Application No. 09/664,364  
Amendment dated  
Reply to Office Action of July 8, 2005

Docket No.: 3449-0131P  
Art Unit 2653  
Page 2 of 39 pages

**Amendments to the Drawings**

Fig. 1

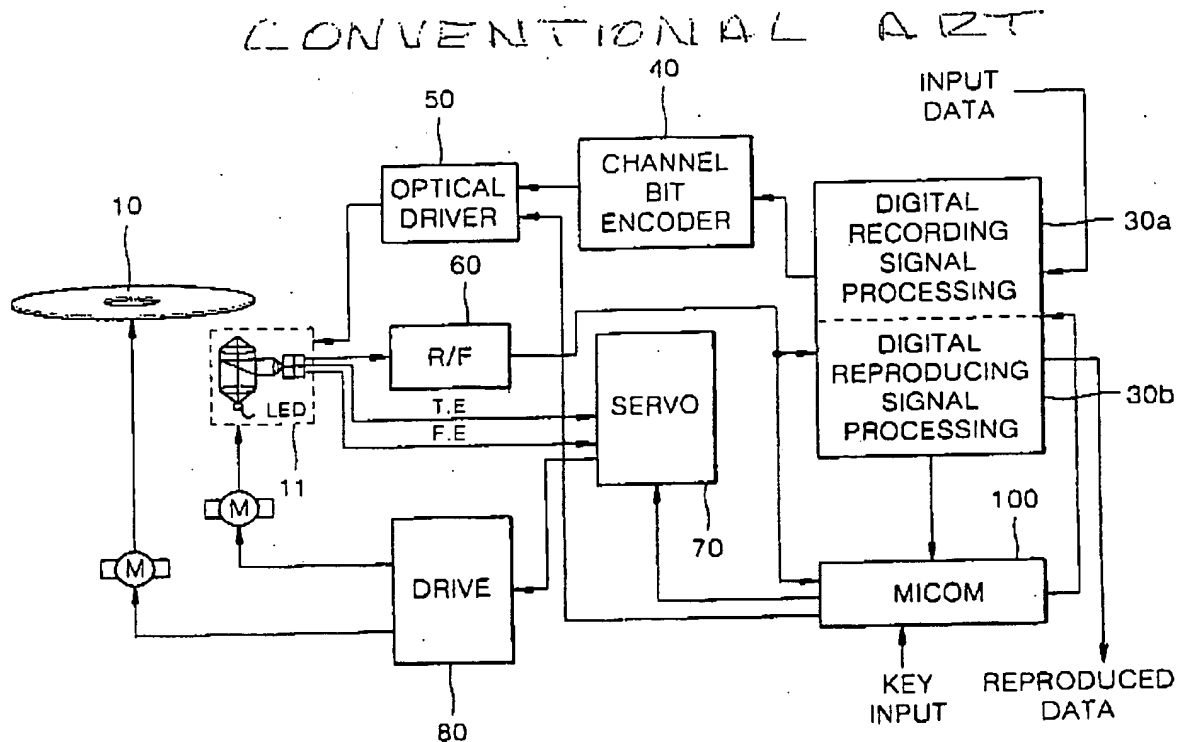
The Examiner has objected to the drawings. The Examiner states that Figure 1 should be designated by a legend such as --Prior Art--.

The attached sheet of drawings includes changes to Fig. 1. This sheet, which includes Figs. 1 and 2, replaces the original sheet including those same Figures.

Fig. 1 has been labeled as Conventional Art

Applicants clearly indicate on page 1 that Fig. 1 illustrates the configuration of a conventional optical recording/reproducing apparatus. Applicants submit that the proposed drawing corrections filed as attachments to this Amendment, which include the label "Conventional Art" meet the criteria of MPEP § 608.02(g) and are sufficient to distinguish Applicants' invention from that which is not Applicants' invention. Accordingly, reconsideration and withdrawal of this objection, and approval of the proposed drawing corrections filed herewith, are respectfully requested.
